Officer Assessment Report

PA2403098 21-53 Hoddle Street,
Collingwood

Officer Assessment Report
Development Approvals & Design

Above: Hoddle Street render showing skybridge on Level 15.

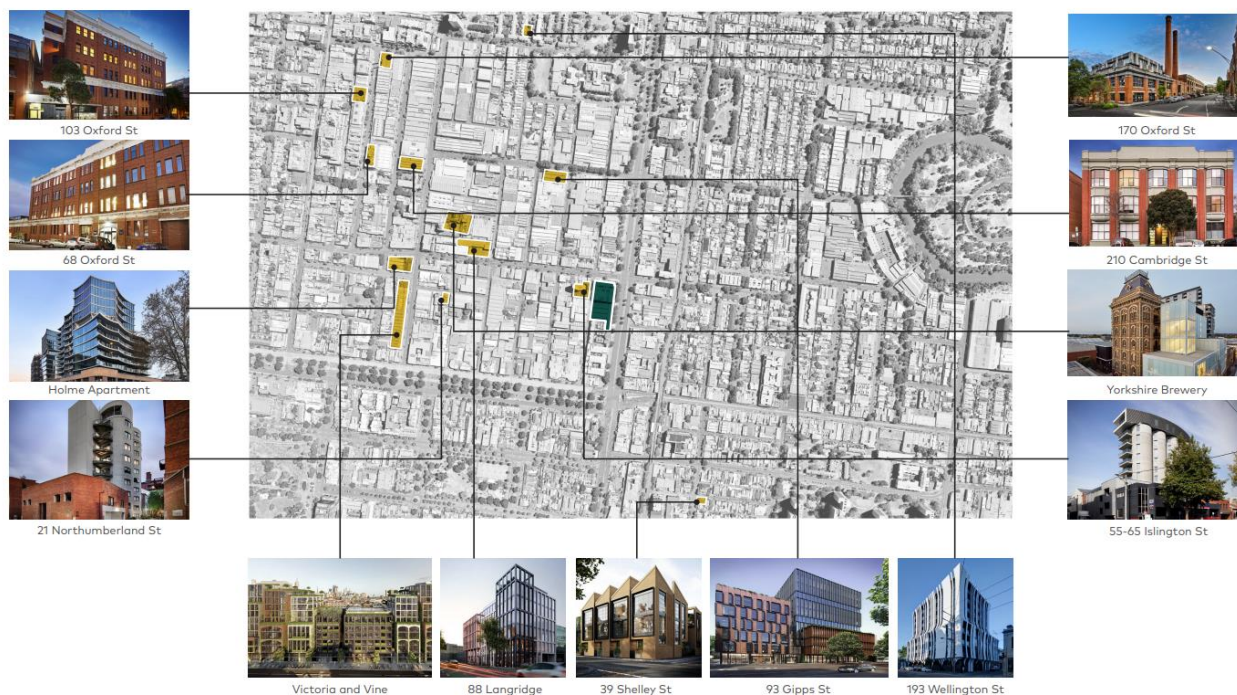
87. Whilst it is acknowledged the sky bridge would result in a slight quicker journey time between each tower, it is not essential, and residents will become familiar with the layout access arrangements of the development. By deleting the skybridge, the break between the tower forms will improve potential visual bulk impacts where the development is viewed from the surrounding area and will reinforce the design intent of providing each of the towers with their own identity. Further, the deletion of the sky bridge will improve the southern and northern outlook of proposed dwellings located immediately below. Therefore, a condition requiring the deletion of the skybridge is recommended to be included on the planning permit.

Above: 9am and 10am shadows to 55 Islington Street (blue=proposed shadows).

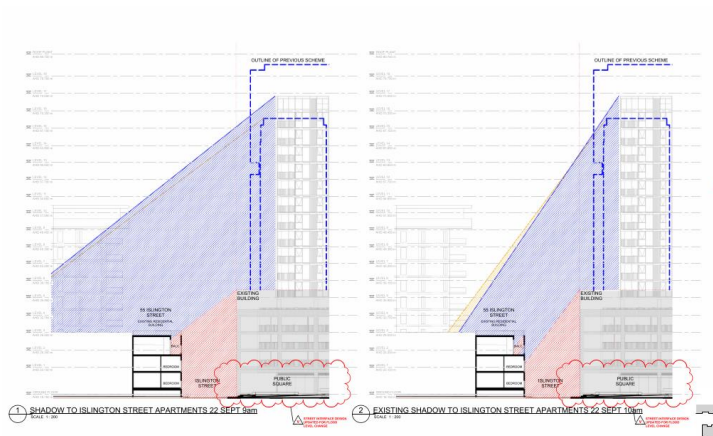
- At 9am, east facing balconies within the Silo Apartment building at 55 Islington Street, will receive new overshadowing to approximately 50% of their area.

- At 10am, the shadows move south, with new shadow impacts limited to a selection of east-facing habitable room windows and a balcony associated with ground, first floor and second floor of the eastern-most dwellings located at 55 Islington Street.

Above: Type A01 dwelling layout.

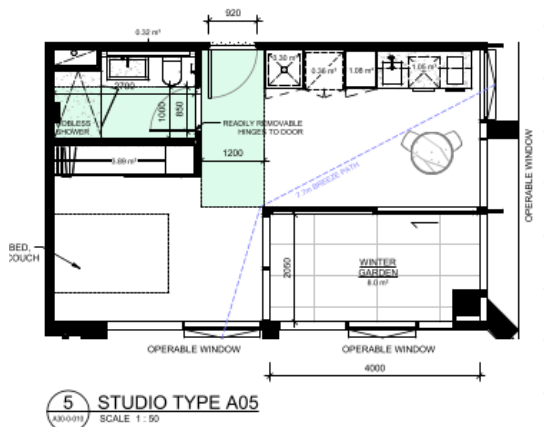
Whilst it is noted Standard D26 (Functional Layout) does not specify minimum bedroom size dimensions for studios, the bedroom dimensions shown above demonstrate that there would be constrained circulation space around the bed and limited space for a bedside table. The Tribunal has previously determined that bedrooms within studios should have a dimension of 3m on at least one side and should be 9sqm in size. The Type A01 layout will not clearly meet the functional needs of residents and given 40 of these apartment types are proposed within the development, an improved amenity outcome is recommended to be sought by conditions.

A condition is recommended to be worded to allow flexibility for the permit applicant to respond with an appropriate option. This could include amalgamation of some apartments for example, or alternatively the internal width of the bedroom space of the Type A01 dwellings could be increased by 600mm, by reducing the balcony depth to 1.2m. A reduced balcony depth would introduce a non-compliance with Standard D20 in some locations (i.e. those that aren't

Above: Proposed alternative Type A05 dwelling layout as shown on the Sketch Plans, dated 13 September 2024.

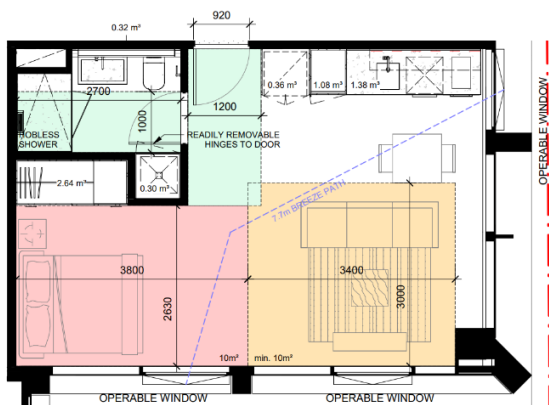
The applicant contends that the above layout is acceptable as the bed will be a 'murphy bed' making the area flexible for conversion into a living room. This not considered to be an acceptable permanent arrangement.

The permit applicant has provided an alternative layout on a 'sketch plan' showing the winter garden removed and converted into living space. This is shown below:

Whilst it is acknowledged that the removal of the winter garden would result in a non-compliance with Standard D18 (private open space), the alternative arrangement is more functional and is acceptable given future occupants will have access to multiple areas of internal and external communal open space within the development. Therefore, a condition is recommended to be included on the planning permit requiring conversion of the Type A05 dwelling layouts to that shown on the sketch plans.

Above: Type A05 dwelling.

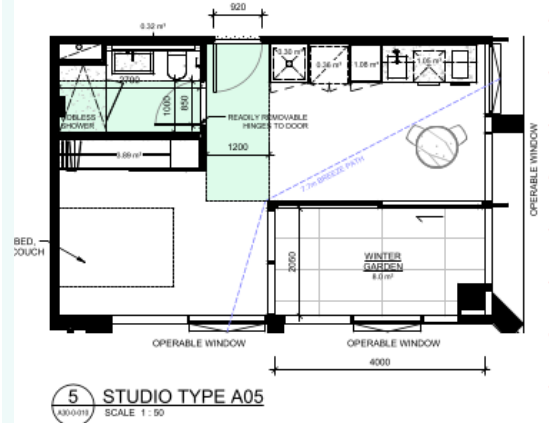
The applicant contends that the above layout is acceptable as the bed will be a 'murphy bed' making the area flexible for conversion into a living room. This not an acceptable permanent arrangement and is not supported.
